ES Service Information

SI0120

Equipment Affected: Chillers with 292/351 & 419/503 VSD Drives

Trap Filter Resistor Wire Routing

FIG.1 - LOCATION OF TRAP FILTER POWER RESISTORS

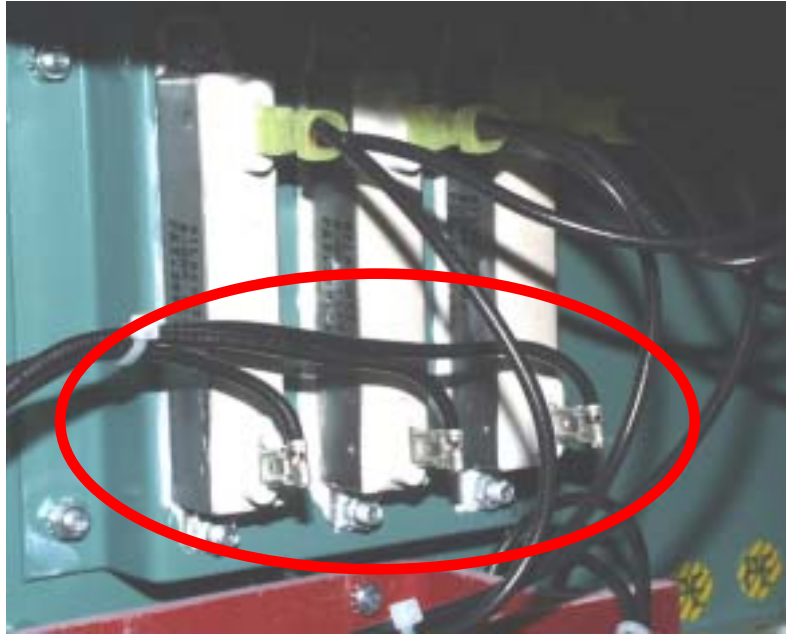
Fig. 1 shows the general location of the trap filter power resistors.
